**Extension to Wood Lane Quarry,
Ellesmere Sand And Gravel Spunhill Ellesmere Shropshire
SY12 0HY
14/0589/MAW**

**Grounds for Objection
- Effect on local landscape, habitats
and wildlife**

**Report to Welshampton and Lyneal Parish
Council**

**Dr J L Daniels
Peatland Ecologist
Resident of Colemere
January 2015**

Figure 2 Designated sites and the White Moss peat body

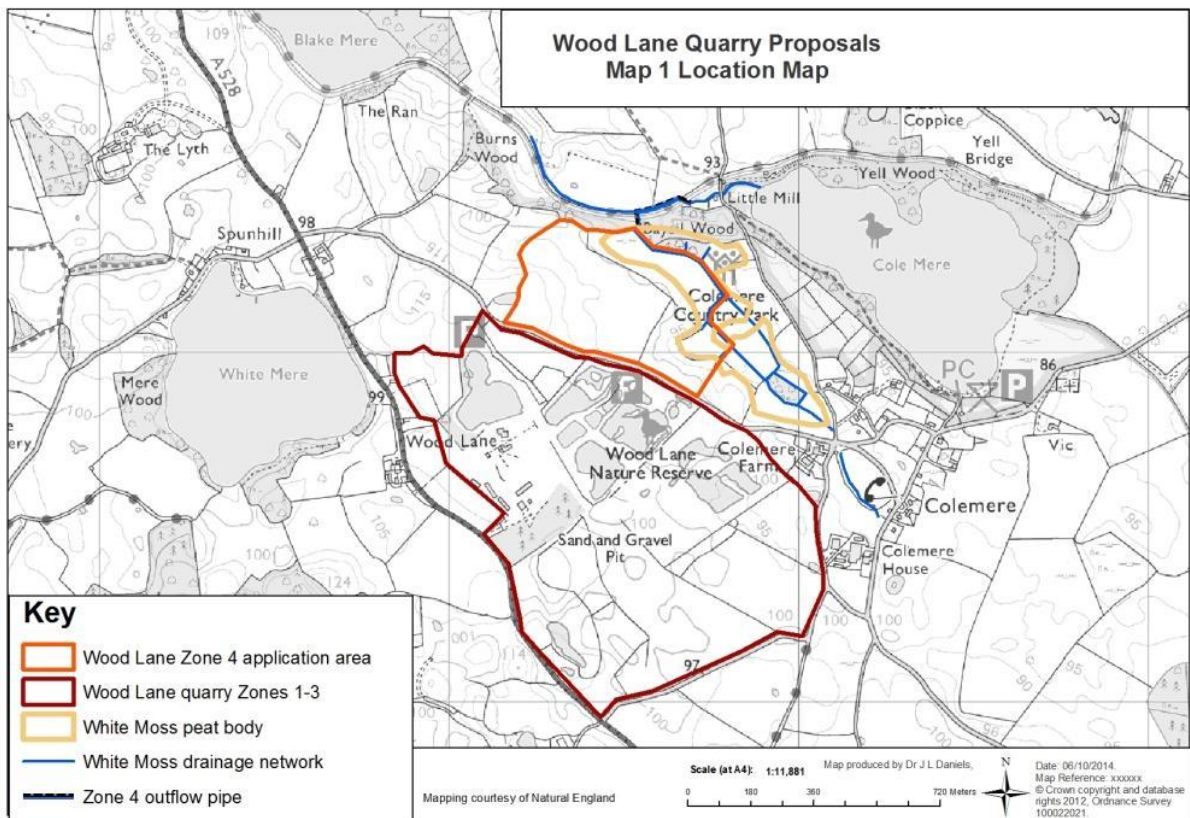
The Zone 4 Proposal Reports ignore their own evidence of the existence of the White Moss peat body (Figure 2), erroneously concluding that the valley wetlands sit on boulder clay. As such, the Reports do not to assess the effect on this deep peat body of quarrying the peat away at the north-east corner of Zone 4, depriving the peatland of surface and subsurface water flow from the Zone 4 slope, placing the peats next to a deep crater or stacking bunds on them. They conclude there will be no detrimental impact of the proposals on the local valley wetlands. Evidence from other local peatlands on sand would certainly contradict this.

2.2. **Relationship of sites.** Figure 2 shows the locations of the 2 Sites of Special Scientific Interests (SSSIs)/ Ramsar wetlands of International Importance and 4 Local Wildlife Sites (LWS) in relationship to Zone 4, and also the peat body which lies along the eastern and north –east of Zone 4 both within and adjacent to Zone 4.

groundwater table, has, over thousands of years, allowed ca11 ha of deep peatland to develop on the sand and gravel at the base of the Zone 4 slope, now at an elevation of ca 89 -90m OD (Figure 2).

Under the Zone 4 proposals, the northern part of the White Moss peatland, at an elevation of ca 89 -90m OD (Figure 2), will apparently in part be quarried away, the central “amphitheatre” area will be used for stacking of storage bunds, and the entire White Moss peatland will be left immediately next to the edge of a deep crater containing a new wetland with a water level at ca 84m OD, 6 m lower.

Figure 3 Surface water flow

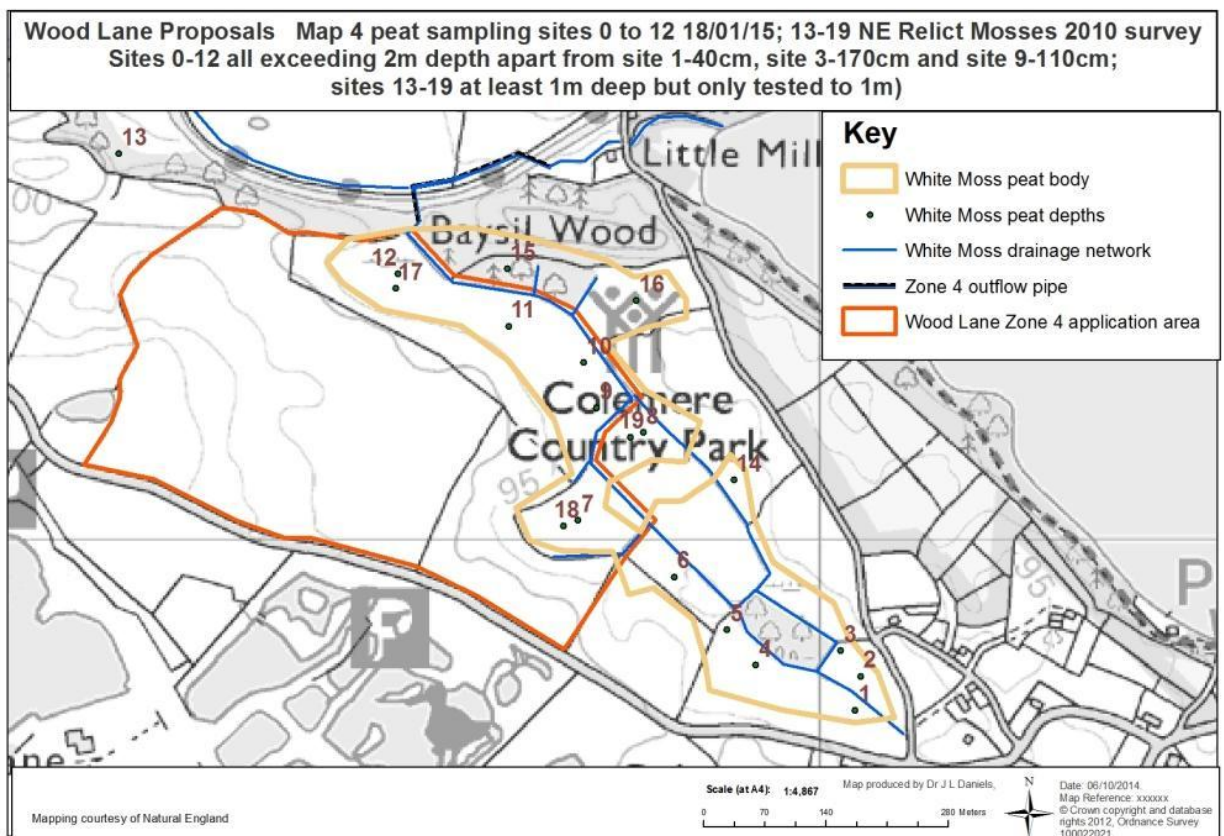
The Hydrogeology report also misrepresents the direction and consequently the amount of surface water flow from the Zone 4 slope into the White Moss peatland (Figure 3), and makes no analysis of the effect of digging a 6-7 m-deep crater alongside these deep peats on the flow of water to "Woodland near Colemere" Local Wildlife site, the valley bottom peatlands or Baysil Fen (collectively the White Moss peatland).

4.3.4. Direction of surface water flow. In the Zone 4 Hydrogeology report, the figure “Surface water system adjacent to Zone 4” incorrectly shows most of the surface water flow occurring to the north-east towards the Baysil wood canal culvert, (in reality plotting an uphill flow). Simple observation of the landform and map contours shows that a very substantial proportion (more than 50%) of the slope drains eastwards into the White Moss peatland (Figure 3). After quarrying, the hydraulic gradient towards the peatland will be reversed away from the peatland, and surface water flow will occur westward into the bottom of the excavation.

Figure 4 Peat sampling locations

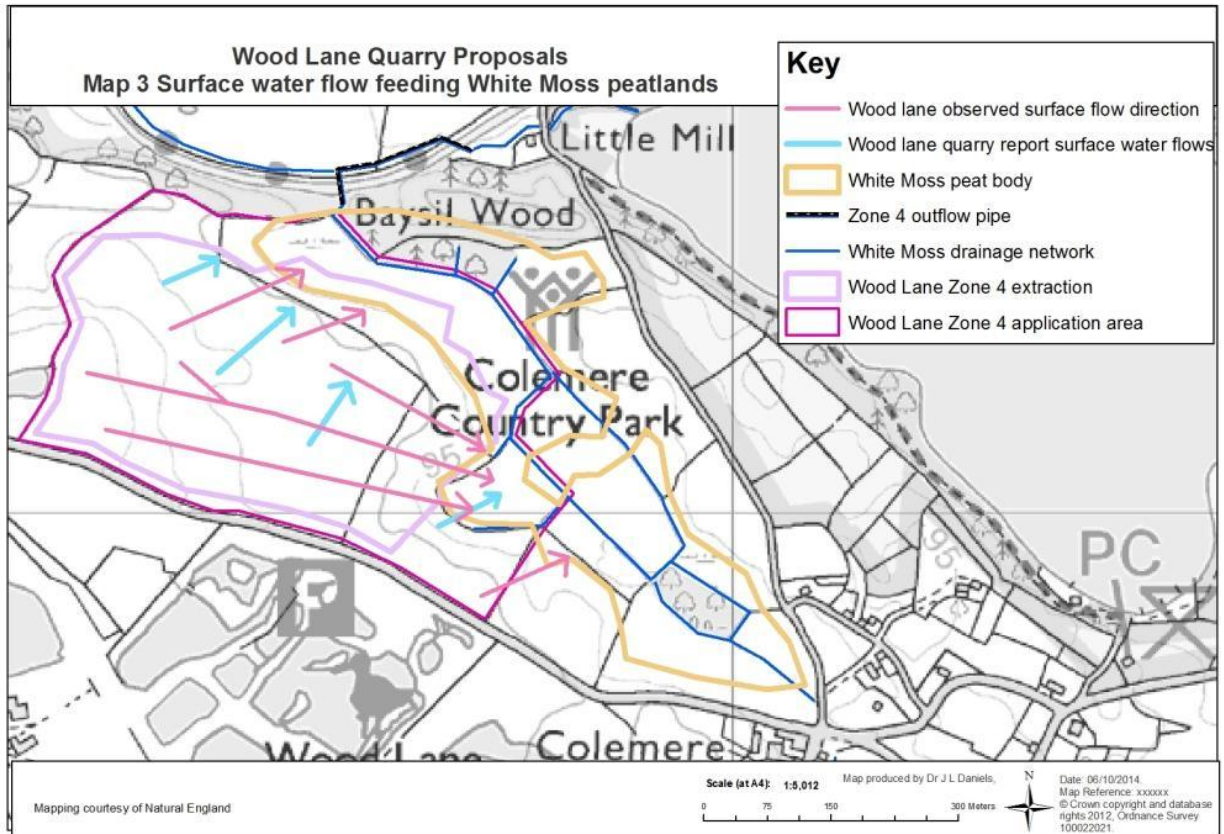
In 2010, the Relict Mosses of Cheshire, Shropshire and Staffordshire survey (Natural England 2010) found deep peats exceeding 1m depth along most of the White Moss peatland (see sites 13-19 on Figure 4. On 18/1/15 J & R Daniels found that most of the valley peats were in excess of 2m, see Figure 4. **The actual depth of these peats and the substrate below and around them should be quantified so the detrimental effects of adjacent Zone 4 drainage can be assessed.**

This covers the peat spur north and east of the central ditch all along the south of Baysil Wood (Figure 4 sites 15 and 16, and the north-western fields on the west of the central ditch (Figure 4, sites 11 and 12).
